Draft decision – Appendices

Queensland

**Draft distribution determination
2010–11 to 2014–15**

25 November 2009

Figure H.1: Comparison of Energex proposed materials cost escalation and AER indicative materials cost escalation (index base year 2007–08 = 100)

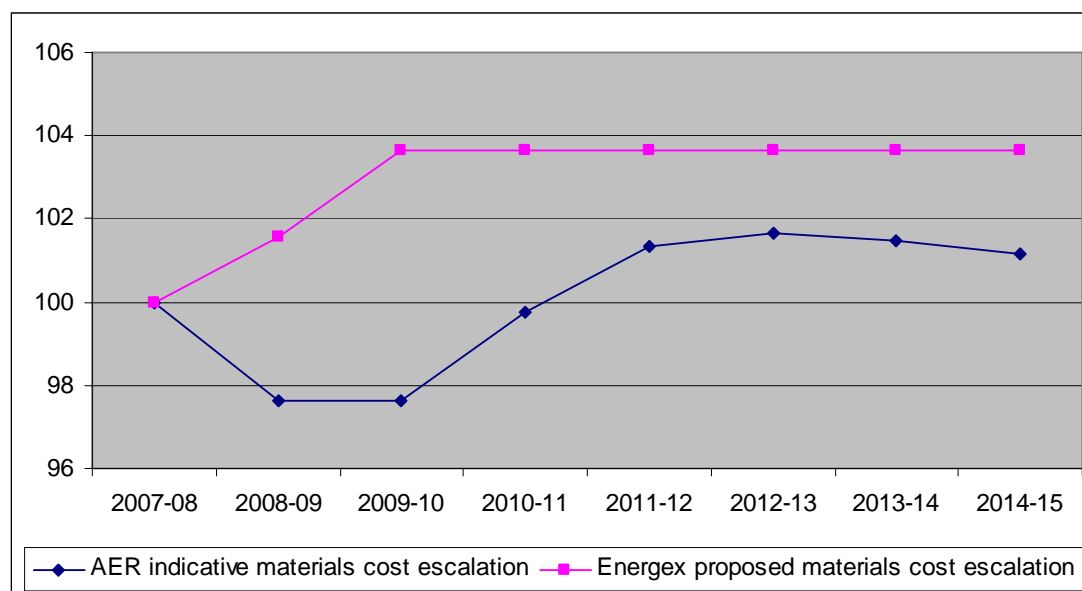
The impact of these cost escalators on costs during the next regulatory control period is shown in figure H.1. It is clear that, because Energex has increased its materials costs in 2008–09 and 2009–10, when costs actually fell significantly and then remained steady, Energex’s forecasts of materials costs during the next regulatory

control period appear to be significantly higher than levels suggested by the AER escalation rates. This is despite the strong recovery in materials prices expected in the early part of the next regulatory control period indicated by the AER's forecast materials escalation rates in table H.2.

The AER also notes that had it used only the cost weightings for Integral Energy, on the basis that its customer density is closest to Energex's, the AER escalator line in figure A.1 would be shifted downwards for the period 2010–11 to 2014–15. However, the AER has decided to include EnergyAustralia's weightings in its analysis in order to provide a more representative (albeit still very limited) sample of DNSPs' cost weightings. On this basis, the AER considers that the escalation rates it has calculated represent the minimum adjustment to Energex's proposed escalators needed to provide a realistic expectation of Energex's materials costs in the next regulatory control period.
